QUAD CITIES NUCLEAR POWER STATION UNIT 1

AMENDMENT TO FACILITY OPERATING LICENSE

Amendment No. 61
License No. DPR-29

ATTACHMENT TO LICENSE AMENDMENT NO. 61

FIGURE
3.5-1

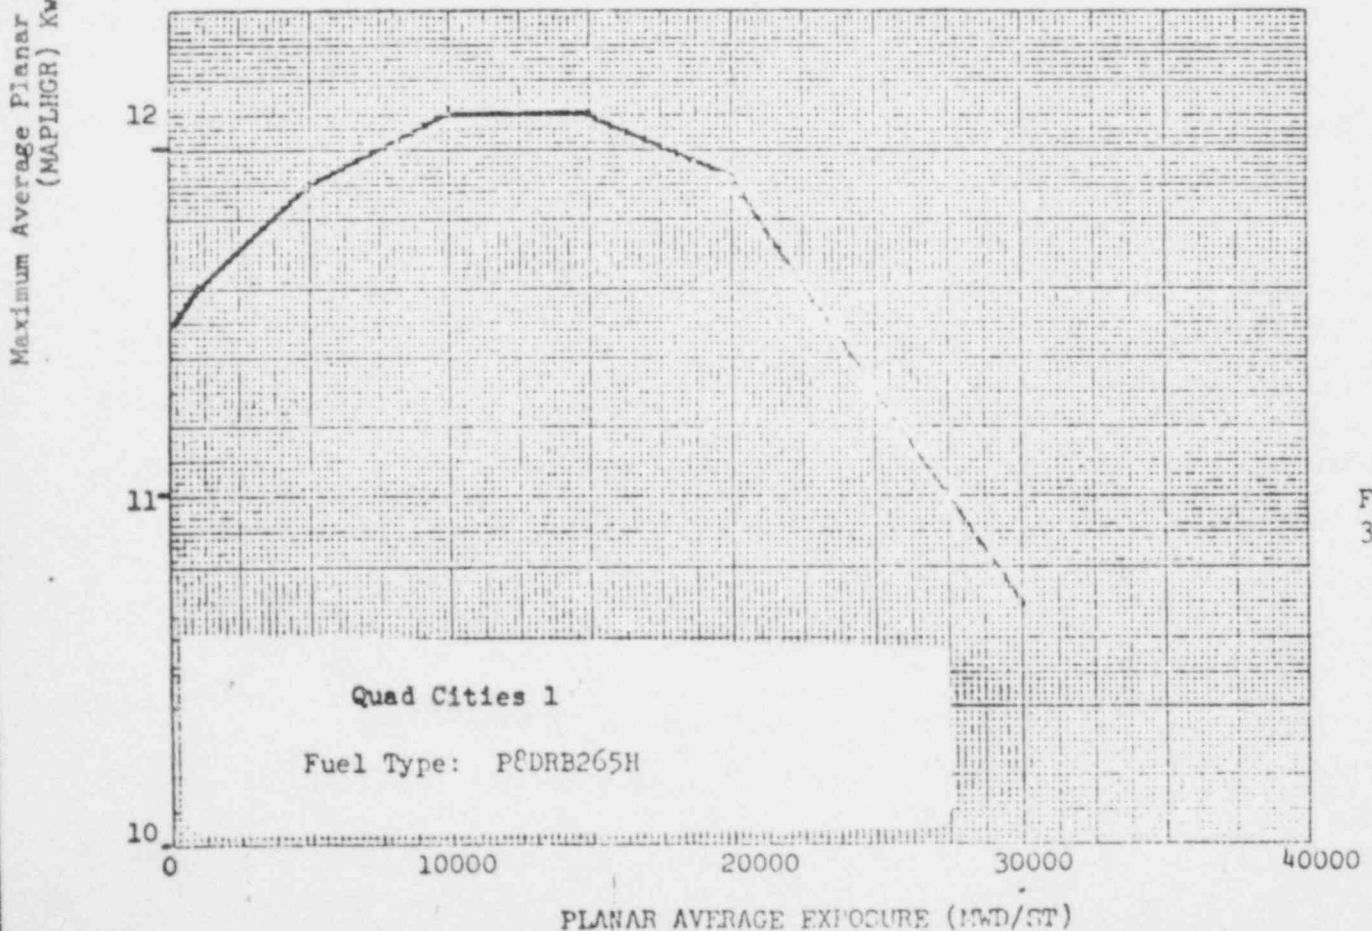
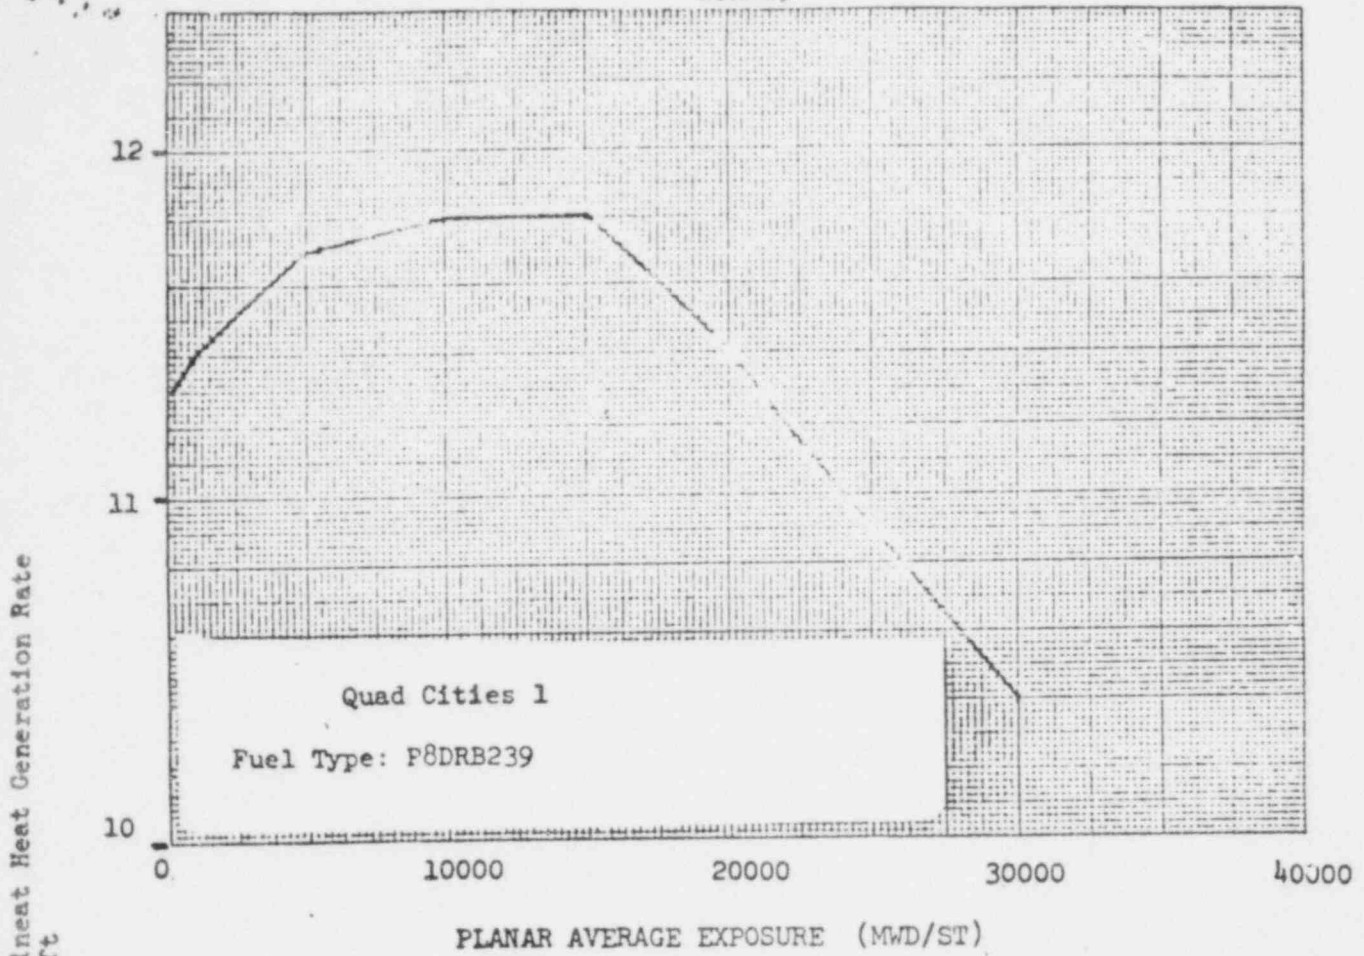
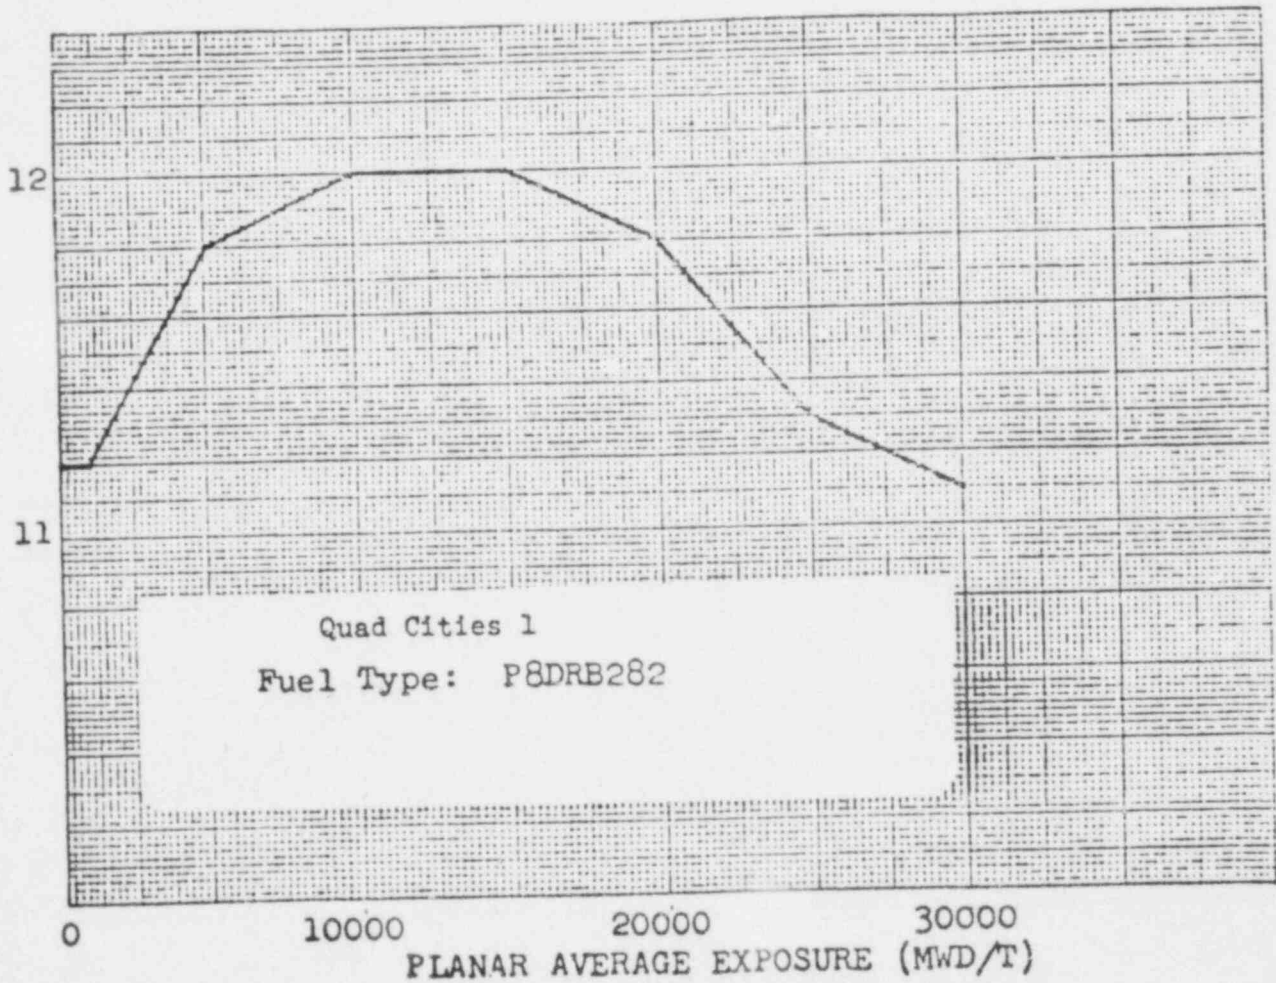
2. Page 1.1/2.1-2a is added.
3. Figure 2.1-2 is deleted.
4. Figure 3.5-1 is being replaced by 6 pages.

During steady-state power operation, the average linear heat generation rate (APLHGR) of all the rods in any fuel assembly, as a function of average planar exposure, at any axial location, shall not exceed the maximum average planar LHGR shown in Figure 3.5-1.

The peak cladding temperature following a postulated loss-of-coolant accident is primarily a function of the average heat-generation rate of all the rods of a fuel assembly at any axial location and is only secondarily dependent on the rod-to-rod power distribution within an assembly. Since expected local variations in power distribution within a fuel assembly affect the calculated peak cladding temperature by less than ±20°F relative to the peak temperature for a typical fuel design, the limit on the average planar LHGR is sufficient to assure that calculated temperatures are below the limit. The maximum average planar LHGR's shown in Figure 3.5-1 are based on calculations employing the models described in Reference 2.
